PLANNING COMMISSION
Regular Meeting
Monday, May 22, 2023
6:00 PM
Christine Nuernberg Hall

Agenda

TO: Planning Commission
FROM: JAC ZADER, ASSISTANT DIRECTOR COMMUNITY DEVELOPMENT
DATE: May 22, 2023
SUBJECT: Jilly's Car Wash. The applicant is seeking master sign plan approval for the property located at 10829 N. Port Washington Road.

TO: Planning Commission
FROM: KIM TOLLEFSON, DIRECTOR OF COMMUNITY DEVELOPMENT
DATE: May 22, 2023
SUBJECT: Aurora Healthcare. The applicant is seeking building and site plan amendment approval to allow for a 2,700 sq. ft. addition for the property located at 6425 W, Mequon Road. REMOVE FROM TABLE

Attachment: Renderings [Revision 1] (8454 : Fifth-Main)

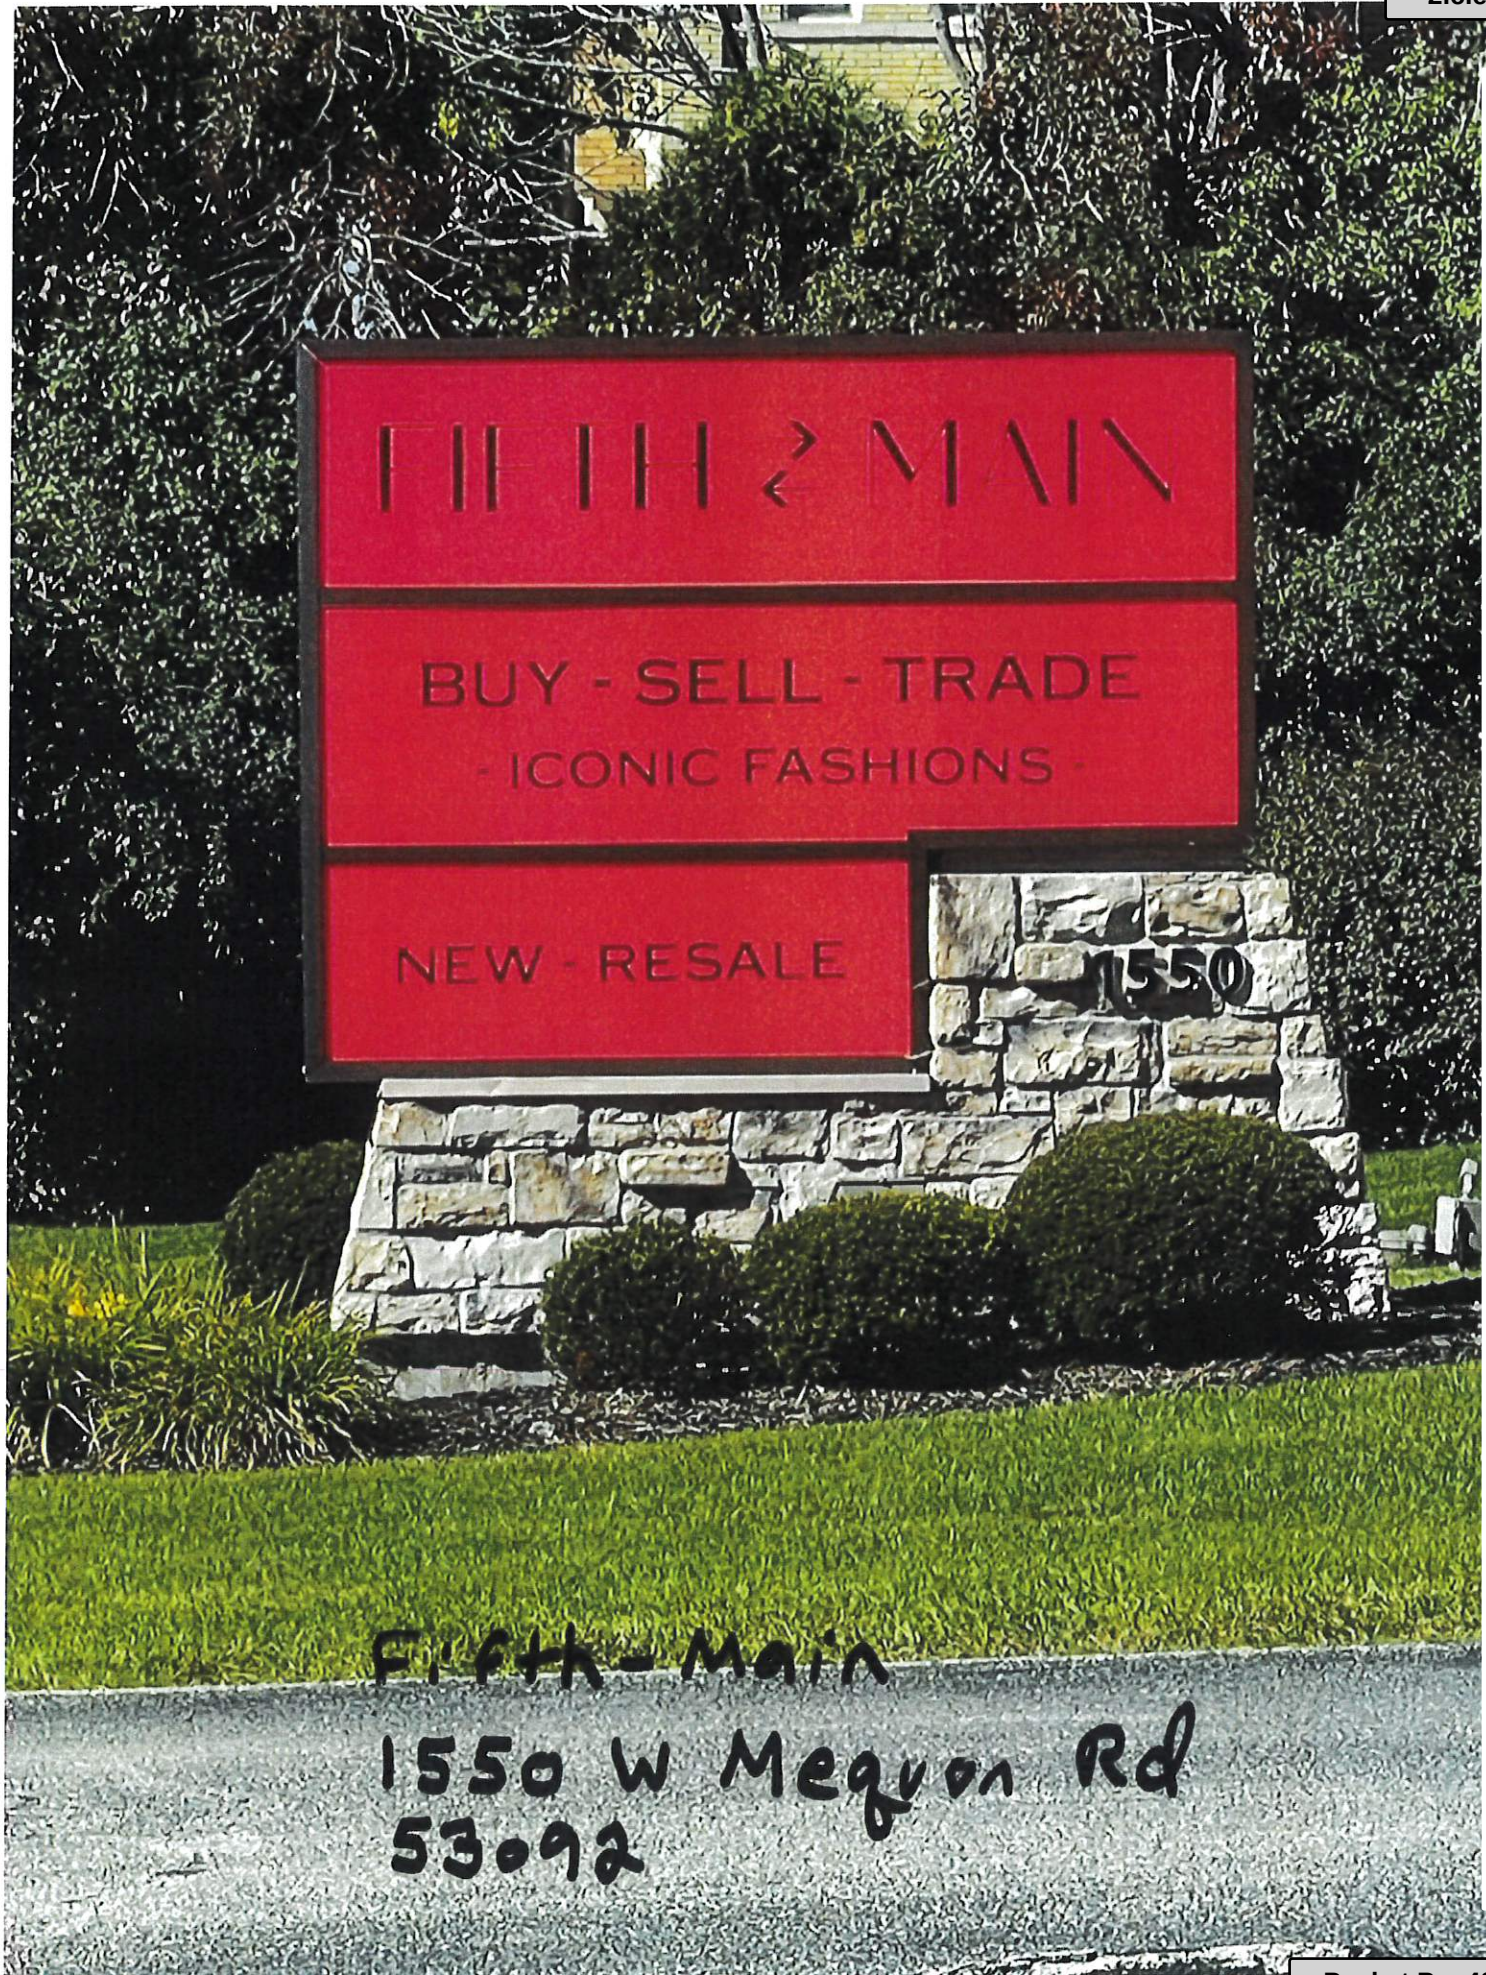
The sign was modified in October (see attached) and generated a significant number of complaints among the public and city officials. The modification was not approved prior to implementation and was no longer in compliance with the original city-approved sign permit. Community Development issued an order for correction, with a deadline of the end of the month due to the applicant's expressed support for Breast Cancer Awareness month. After the deadline for compliance passed, the applicant indicated the sign would remain as the permanent sign. Since then, the sign was modified to include only the narrow pink pinstripe (see attached Silver Leaf Signs & Graphics monument sign artwork and detail).

Does not Complies. The use of pink does not follow the color scheme of the building. In addition, the original building and site plan approval relied on earth tone colors for the structure, stone and site theme.

The sign complies with the quantitative technical standards of the Sign Code. Staff do not find that the pink pinstripe is consistent with color scheme of the building. In staff’s opinion, if the applicant would like a contrasting color on the sign, then the color should be modified to be in

keeping with the building's current color scheme and the applicant should submit a proposal, for staff review and approval, that incorporates the revised color as an accent throughout the site. Alternatively, the applicant can use a color consistent with the building as is.
